# Thoughts on IEEE 802.3 ap Draft 2.0 Comments #128 and #129

John D'Ambrosia  
Tyco Electronics

# Comment #128

# Comments Regarding Channel Return Loss

## SDD11 / SDD22

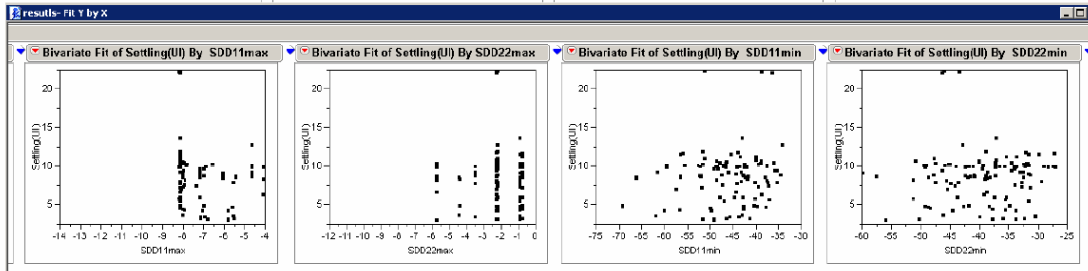
- No correlation

Settling time identified as indicator of difficulty to equalize channel

No correlation between channel return loss and settling time identified

# Use of Return Loss Mask?

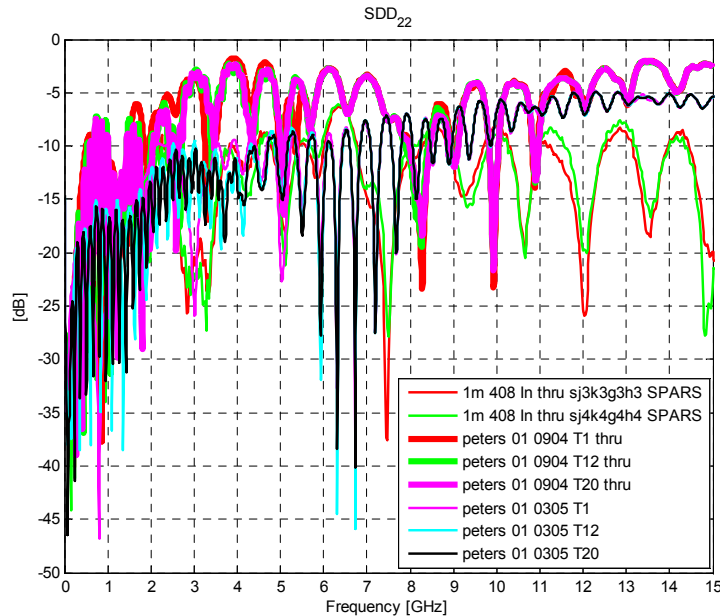
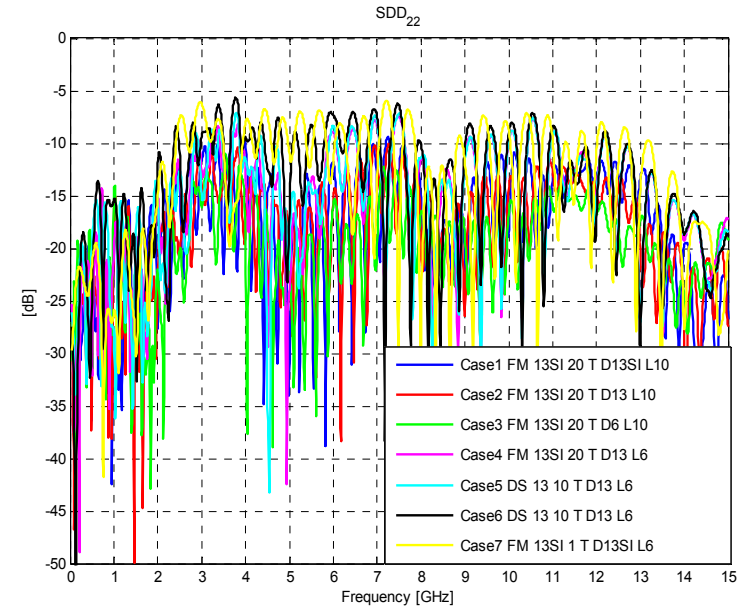
- Per IBM analysis (abler\_01\_0305, seemann\_01\_0305) only two channels failed with no xtalk conditions (Peters\_01\_0904 T1 / T12). Analysis did not include Peters 0305 M/B channels.
- One universal mask does not take into account symbiotic relationships that exist in complete channel.
- Channels passing with similar to higher return loss
  - Case#3 failed Amin
  - Case#6 – gray zone for Ilmin and –Peak Deviation

- Of 8 channels failing
  - 3 failed fitted ICR only
  - 1 failed fitted ICR, ILmin, Amin
  - 2 failed peak deviation mask
  - 2 in “grey zone” for ILmin and peak deviation mask
- All 6 Intel “T” channels failed–
  - 1 of 6 failed fitted ICR,
  - 5 of 6 failed or were “may” of multiple parameters for each case

# Revisiting ICR Analysis by Quake

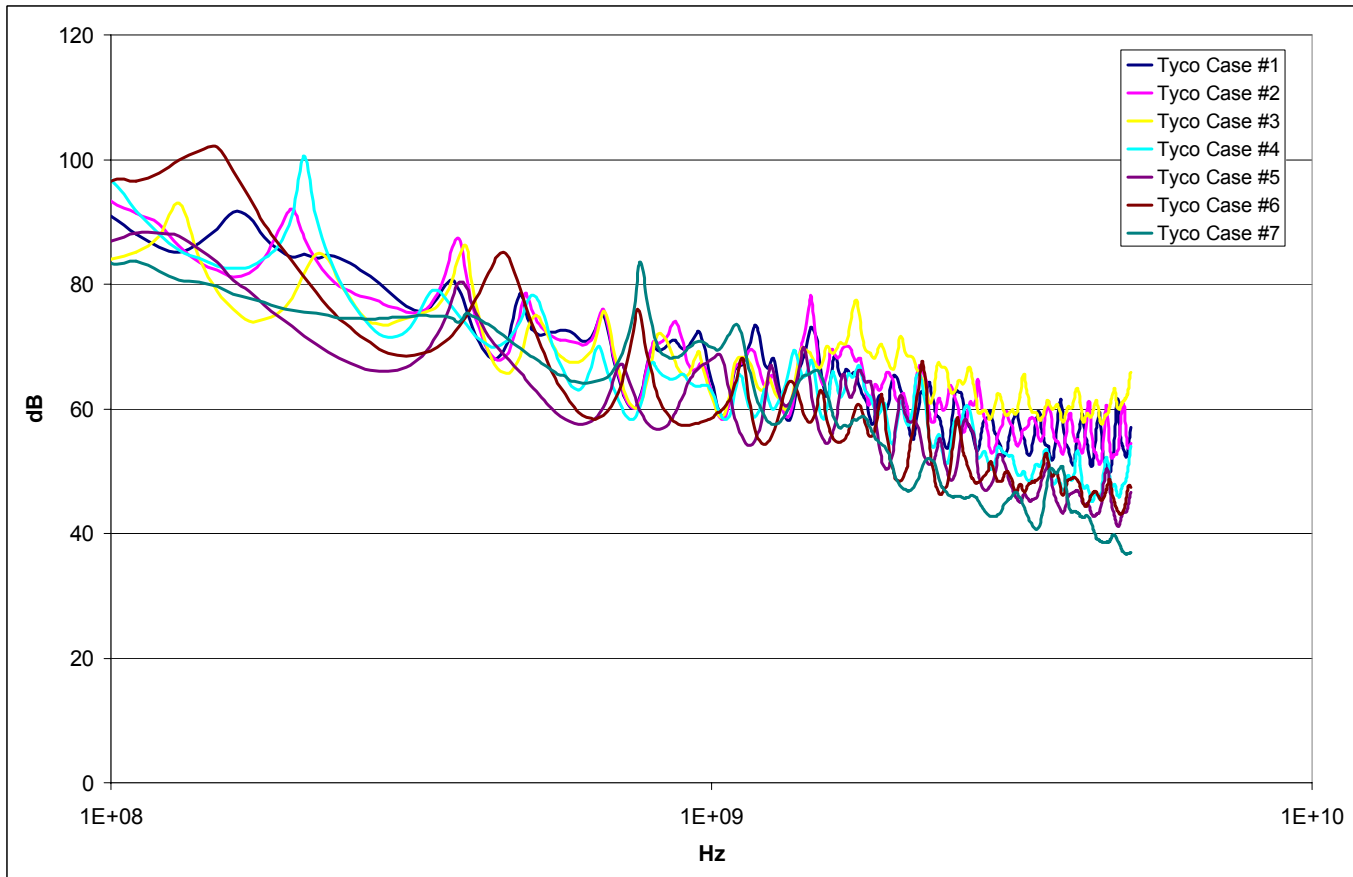
No observed trends from any  
analysis seen.

# Consider Self-Interference (SI)?

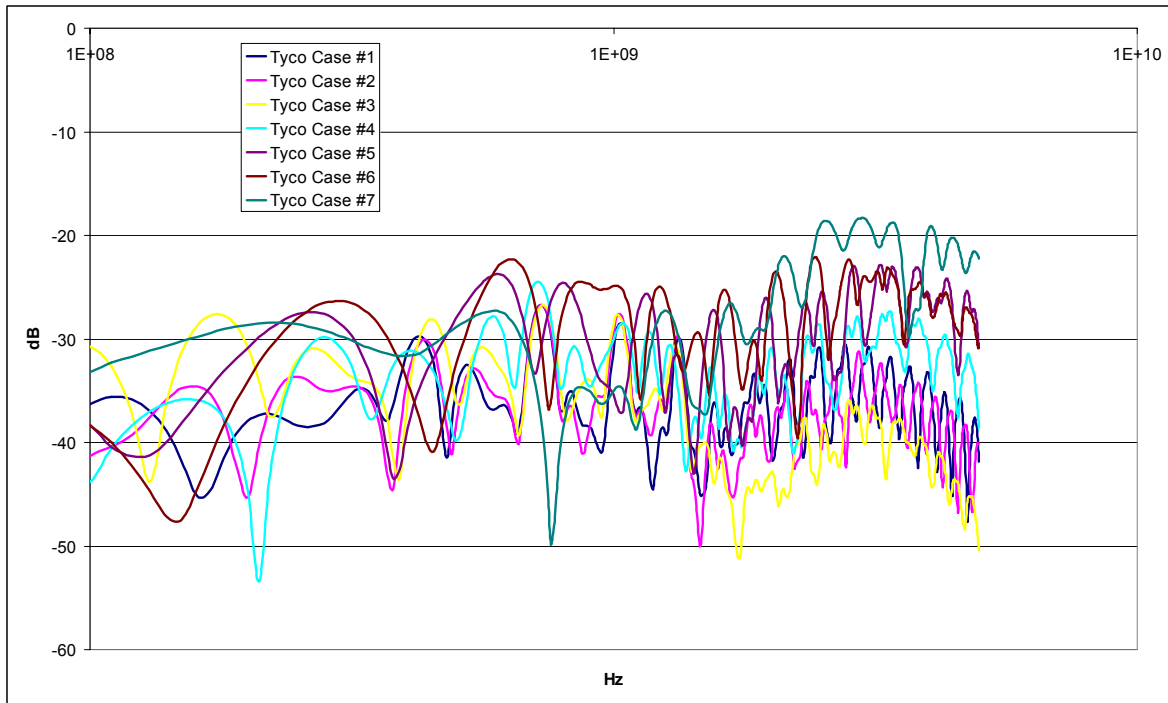
Only trend noted that SI varies with SDD21.

Lowest SI relates to channels with lowest SDD21.

Highest SI relates to channels with highest SDD21.

# Calculate ICR Using Effective SDD21?

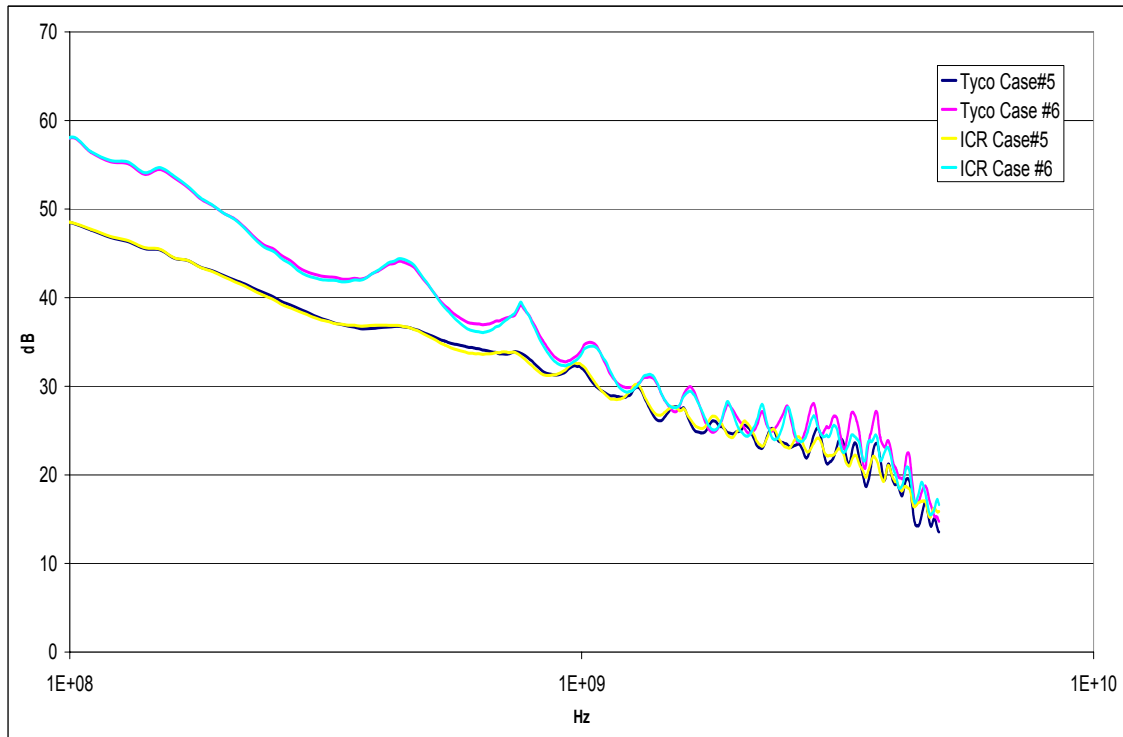
No observed significant differences between ICR and ICR calculated using effective SDD21

# New Channel by Tyco

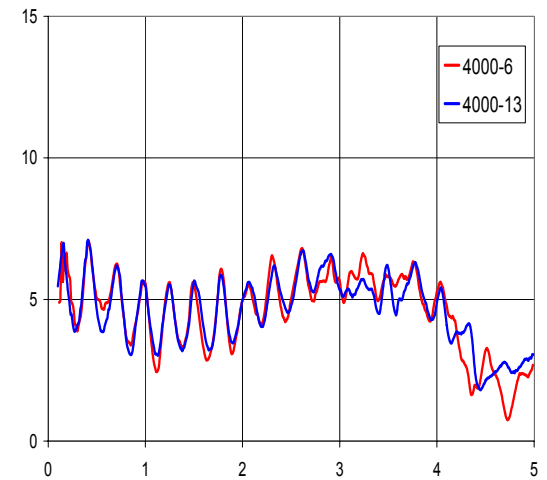
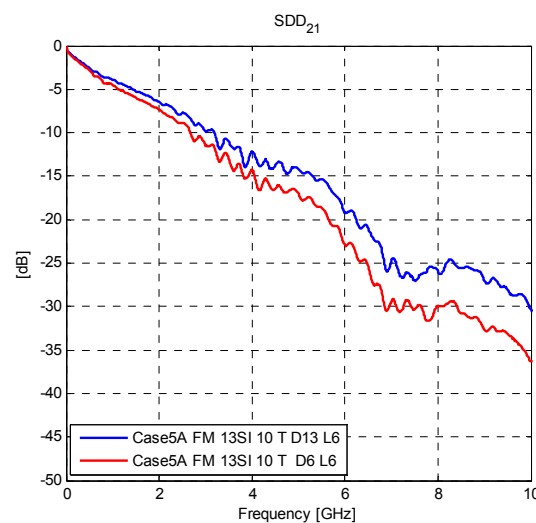
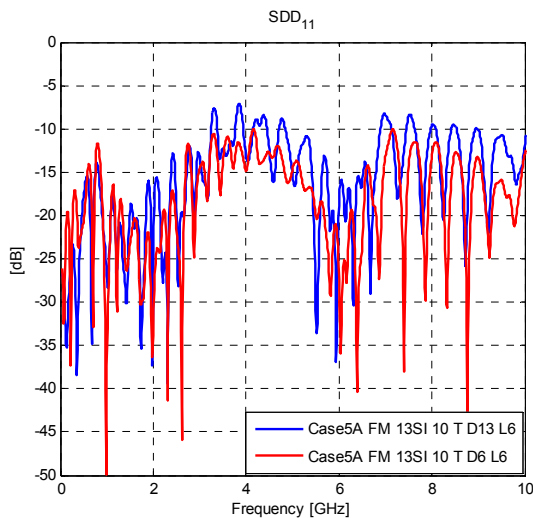
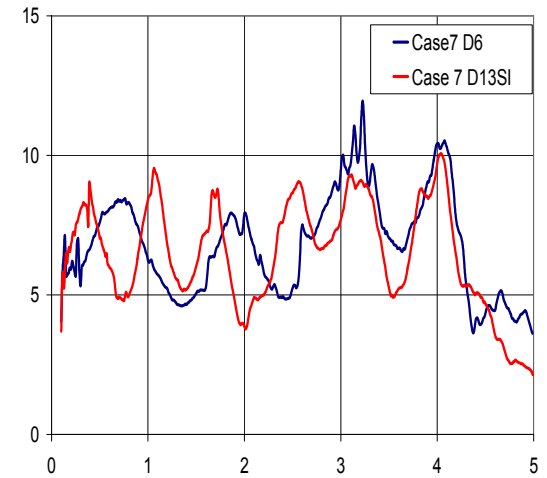
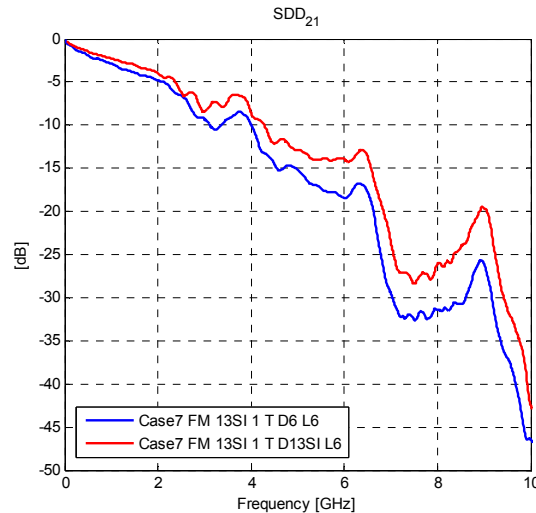
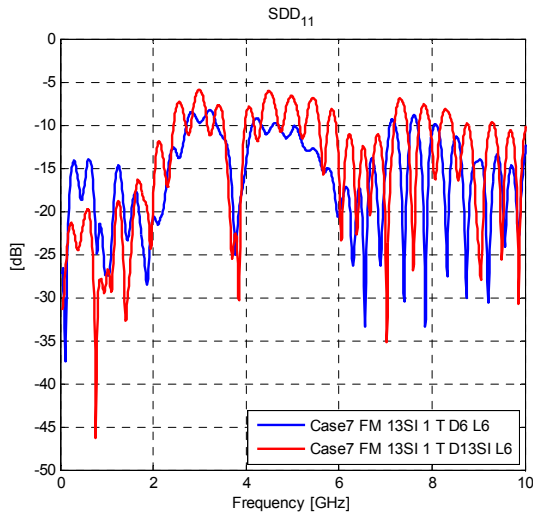
- Tyco looked at a case similar to Case#5, but using the full mesh ATCA backplane, instead of the dual star. Data taken with 4000-13 line cards and 4000-6 line cards.
- Tyco supplied data using 4000-6 6" line cards for Case #7
